PCN – Process Change Notification

Change:	CAB.Xxx Series
Date:	20/08/2015
Author	AD

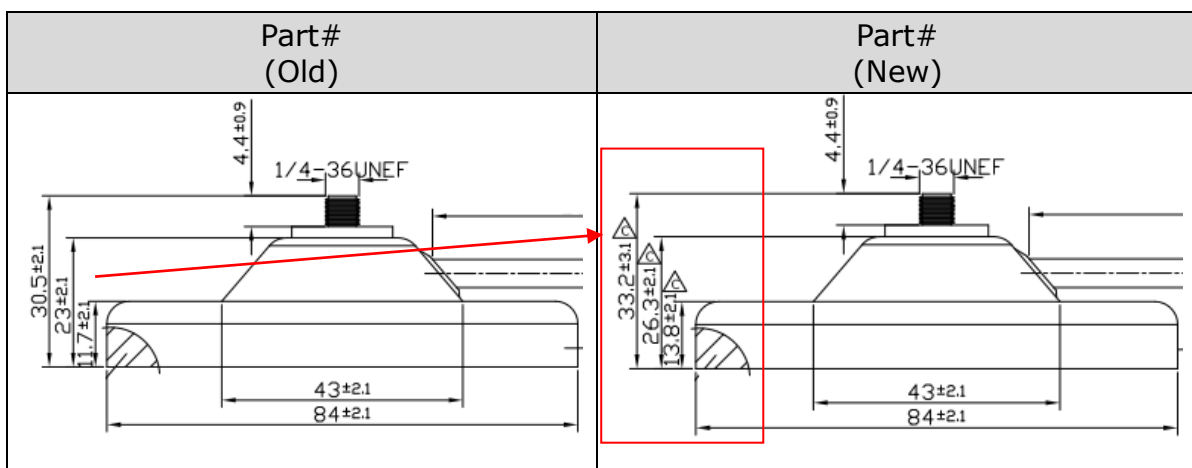
The material of the SMA(F) Connector on the Magnetic base has been changed from SPCC Steel to Acrylonitrile Styrene Acrylate (ASA) Plastic, this has led to some slight modification on the housing dimensions.
